<b>COA #</b> <b>2010-COA-270 (IRV)</b> <b>2010-COA 294 (IRV)</b> <b>2010-VHP-010</b>	<b>INDIANAPOLIS HISTORIC PRESERVATION COMMISSION</b> <b>STAFF REPORT</b>	<b>Hearing Date</b> <b>AUG. 4, 2010</b>
<b>5505 E. WASHINGTON ST. (includes 2 parcels)</b> <b>IRVINGTON</b>		New Case
<b>Applicant: Irving Theater Building LLC by Dale Harkins</b> mailing address: 5505 E. Washington St. Indianapolis, IN 46219		
<b>Owner: Same as Above</b>		Warren Twp. Council District 21 Benjamin Hunter
<b>COMBINED CASE</b>		
<b>IHPC COA: 2010-COA-270 &amp; 294 (IRV)</b> Remove a tree in the rear yard, erect fencing to create dumpster screening and Variances of Development Standards.		
<b>VARIANCES: 2010-VHP-010</b> <p style="text-align: right;">Variance of Development Standards to allow:</p> <ul style="list-style-type: none"> <li>• Reduced parking (8 spaces when 40+ are required)</li> <li>• Reduced dumpster screening (1 side when 3 sides are required)</li> <li>• Location of dumpster in rear transitional yard (not permitted).</li> </ul>

Site Plan – Illustrating 8 parking spaces (existing) and proposed location for dumpster and screening.

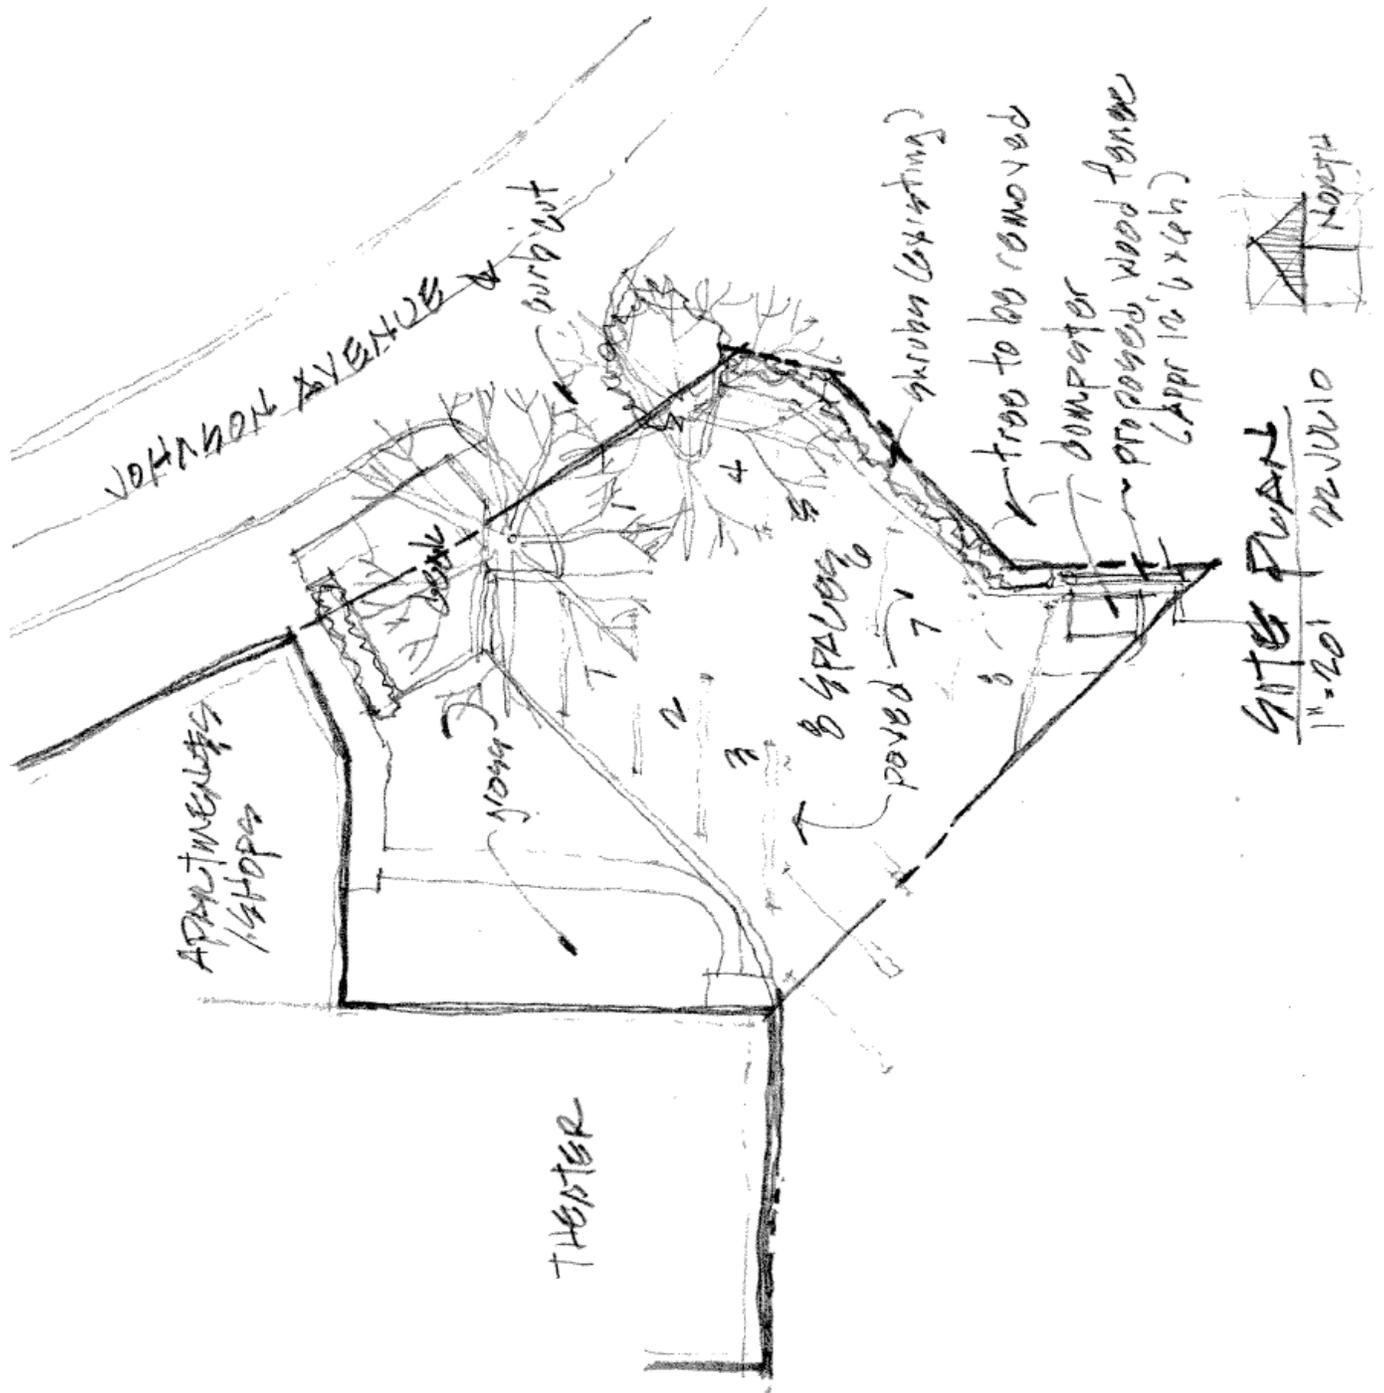
The applicant proposes maintaining the 8-yard dumpster in its current location at the rear of the lot. The applicant indicates the dumpster has occupied this location since at least 2003. This is within the required 20 foot rear transitional yard. Transitional yards are required when a side or rear lot line abuts a protected district and the rear of this lot abuts the beginning of the D-5 residential area located south of Washington Street. *(Presently, the applicant is also the owner of the D-5 lot and single family residence that is immediately adjacent to the rear parking area.)*

Staff inquired about locating the dumpster in the green space behind the building or on the interior of the building. The applicant does not wish to pursue these options because of the difficulty of maneuvering such a large dumpster around vehicles in the parking lot on a regular basis and/or blocking a parking space to allow the dumpster to be maneuvered. Also, this would cause the

dumpster to be in much closer proximity to the outdoor dining area at the south end of the building, potentially creating odor issues for the café.

Additionally, the applicant requests to screen the dumpster on just one side, the east side, when the ordinance requires a minimum of 3 sides be screened. The screening will consist of a 6 ft. solid wood privacy style fence that runs approximately 12 ft. along the lot line between the C-4 and D-5 district. It will require the removal of a tree in order to ensure the dumpster and screen is located entirely on the applicant's property. The applicant did consider ways to screen the dumpster on at least 3 sides but doing so would cause him to lose 1 parking space, front the open side toward the church building to the south, or obtain an easement from his neighbor to the west to locate the dumpster partially on their property. The applicant does not wish to pursue any of these options.

**To approve a Certificate of Appropriateness to remove one tree located at the south end of the property and to construct a 6 ft. solid wood privacy fence (approximately 12 ft. in length) all per submitted documentation and subject to the following stipulations:**

1. **Maximum allowed height of new wood privacy fence is 6 feet. If the fence exceeds this height, a variance will be required.**
2. **Fence shall be confined to owner's property. Fencing placed in or near the public right-of-way may need further approval. Contact the City Controllers office at (317)327-4312 to verify.**
3. **The stump of the tree shall be ground to grade or below grade.**
4. **The stump site shall be backfilled and graded to match existing grades.**
5. **Parking lot shall be striped per the site plan provided.**
6. **No changes to the design or project scope are permitted without prior consultation with IHPC staff. Contact IHPC staff prior to performing any unexpected repairs.**
